Intersection ID: 30412	Main Street: COVENTRY_ROW_CT	Cross Street: SARDIS_RD	Location:	S
ADA ID: CF13933DD3B6	Ramp Type: ParaDiag	Initial Pass/Fail: Fail	Overall Compliance: No	Severity Score: 47.5

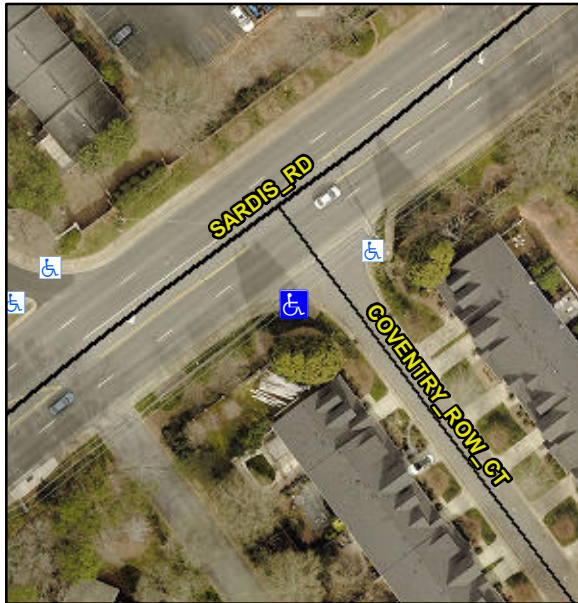
Compliance	Description	Data	Compliance	Description	Data
N/A	Ramp Length LT (in)	66.0	N/A	Ramp Length RT (in)	71.0
No	Ramp Width LT (in)	29.5	No	Ramp Width RT (in)	29.5
Yes	Ramp Slope LT (%)	6.3	Yes	Ramp Slope RT (%)	5.9
No	Ramp XSlope LT (%)	5.1	No	Ramp XSlope RT (%)	3.6
N/A	Landing Length (in)	N/A	N/A	DWS Provided?	N/A
N/A	Landing Width (in)	N/A	N/A	DWS Contrast?	N/A
N/A	Landing Slope (%)	N/A	N/A	DWS Length (in)	N/A
N/A	Landing X Slope (%)	N/A	N/A	DWS Full Width?	N/A
N/A	Landing Curb? (Y/N)	N/A	N/A	DWS Offset (in)	N/A
N/A	Shared Landing?	N/A			
N/A	Gutter Ponding?	N/A	N/A	Gutter Slope (%)	N/A
N/A	Gutter Lip Ht (in)	N/A	N/A	Gutter X Slope (%)	N/A
N/A	Painted X Walk1?	No	N/A	Painted X Walk2?	No
	X Walk 1 Direction	To NE		X Walk 2 Direction	To NW
N/A	X Walk 1 Width (in)	N/A	N/A	X Walk 2 Width (in)	N/A
	X Walk 1 Slope (%)	0.1		X Walk 2 Slope (%)	1.1
	X Walk 1 X Slope (%)	0.5		X Walk 2 X Slope (%)	0.5
N/A	Ramp inside XWalk1?	N/A	N/A	Ramp inside XWalk2?	N/A

Road Slope (%)	1.3	N/A	Clear Space?	N/A
	Road X Slope (%)	0.8	N/A	Clear Space to XWalk (in)	N/A
N/A	Any Obstructions?	N/A	N/A	Storm Grate/Utility Hazard?	N/A
	Obstruction Type			Storm Grate/Utility Type	
		N/A			N/A
			Yes	Surface Condition? (G/P)	Good
			N/A	Curb Slope (%)	9.3

**Remove & Replace Curb Ramp With Two New Directional Ramps or Equivalent.**
